GLIFWC Wetlands Attachment

Analysis of Indirect Wetland Impacts from Groundwater Drawdown

Figure 2: Impact Zones
Impact Zone 1 (0 - 1000 feet)
Impact Zone 2 (1000 to 2000 feet)
Impact Zone 3 (2000 to 5000 feet)
Impact Zone 4 (5000 to 10000 feet)
Proposed Mine Pits (year 20)

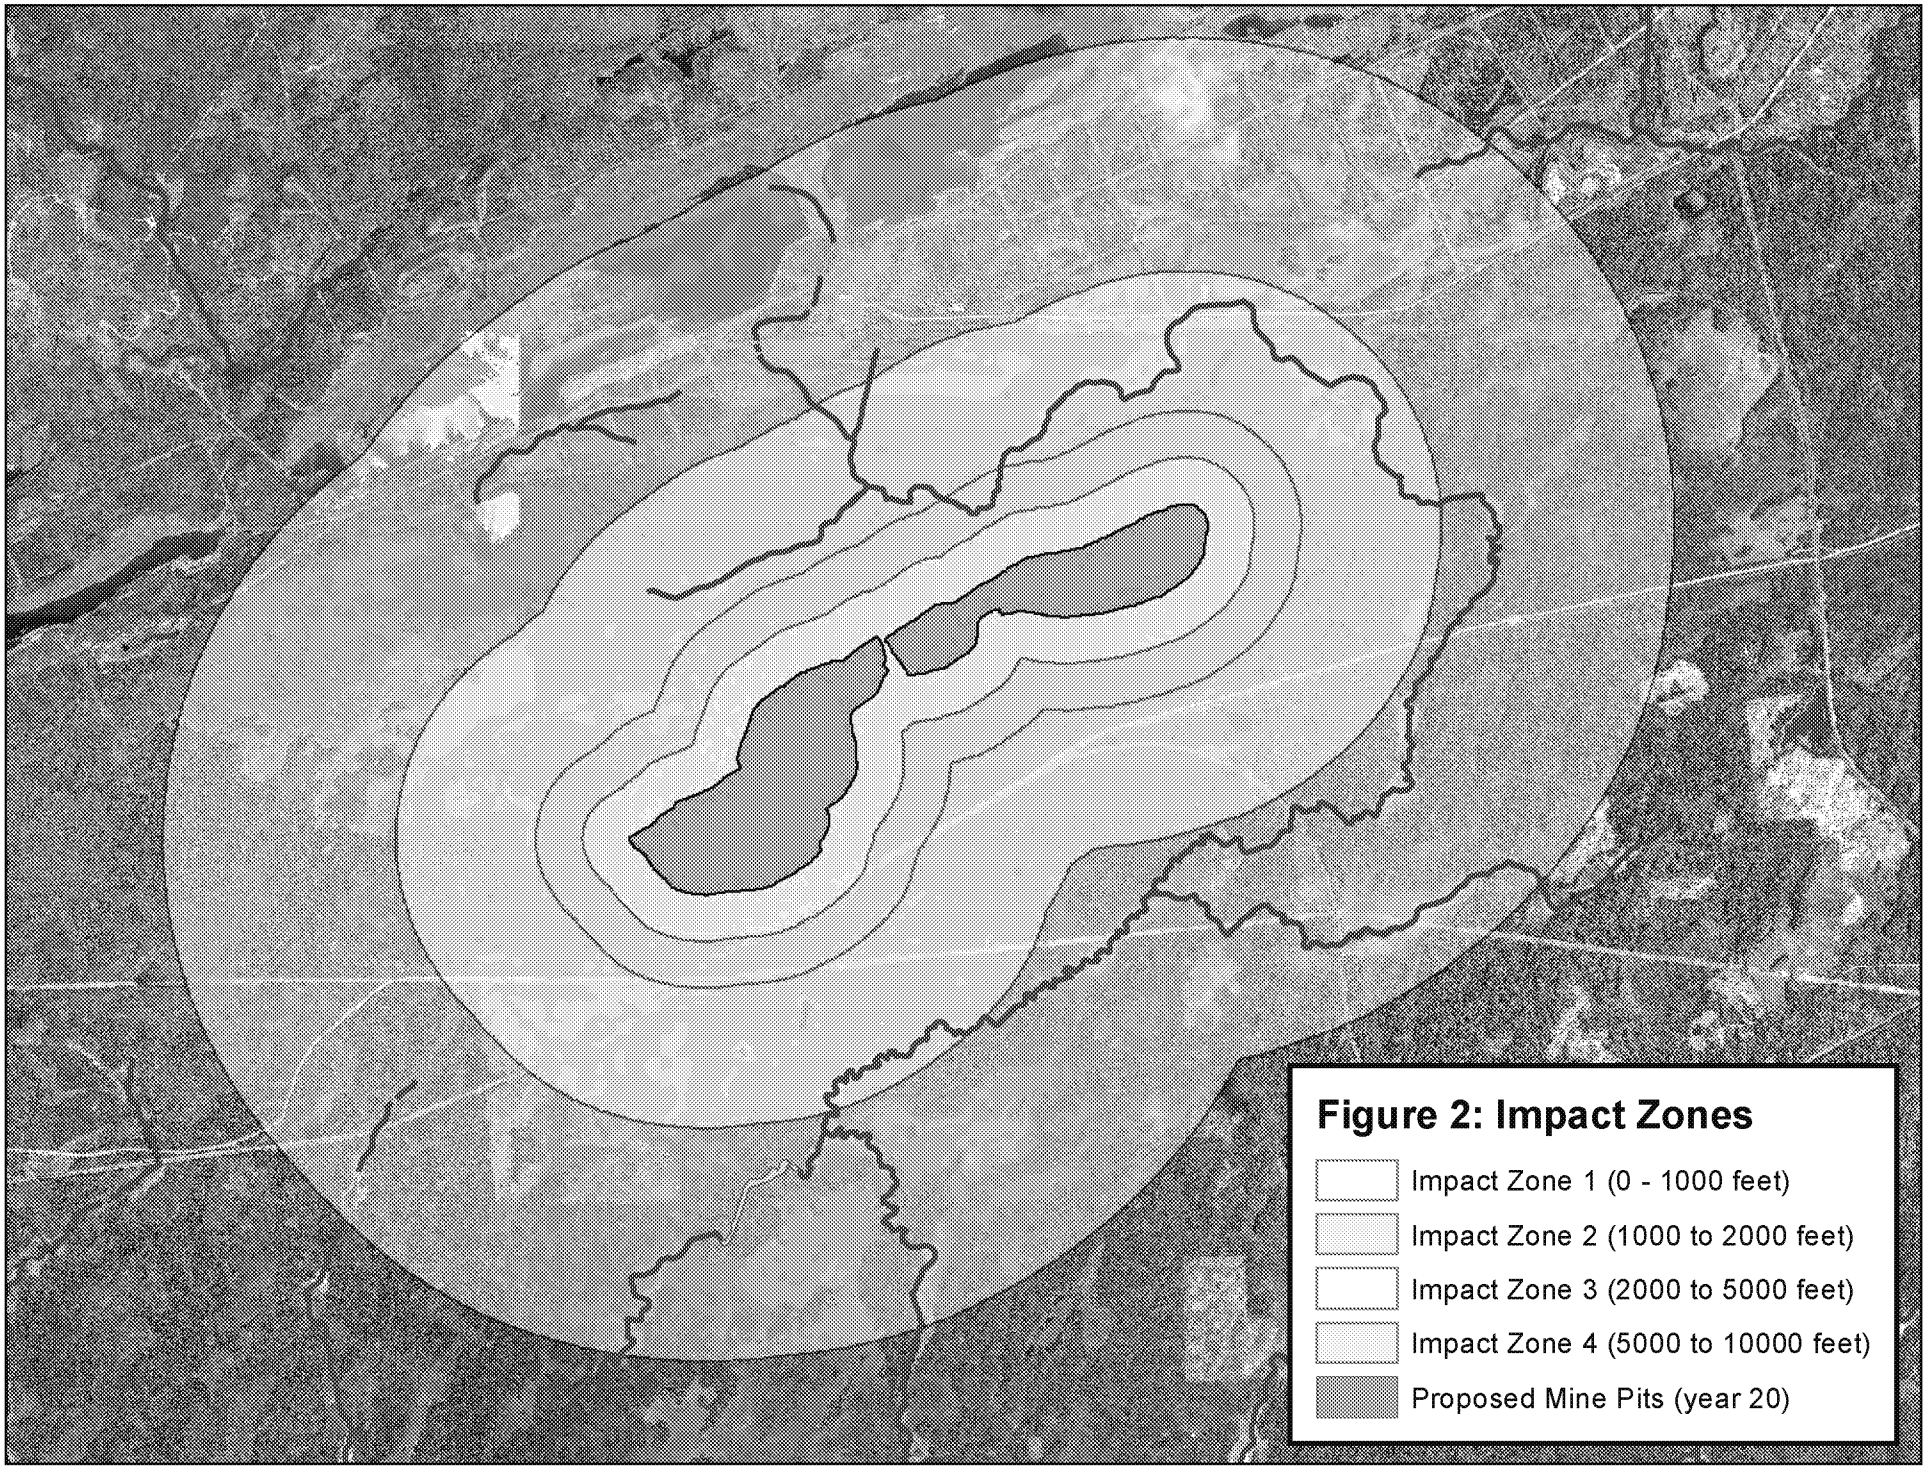
GLIFWC impact zones (Figure 2) are:

- Zone 1 – 0 to 1000 feet from the mine pit edge.
- Zone 2 – 1000 to 2000 feet from the mine pit edge.
- Zone 3 – 2000 to 5000 feet from the mine pit edge.
- Zone 4 – 5000 to 10000 feet from the mine pit edge.
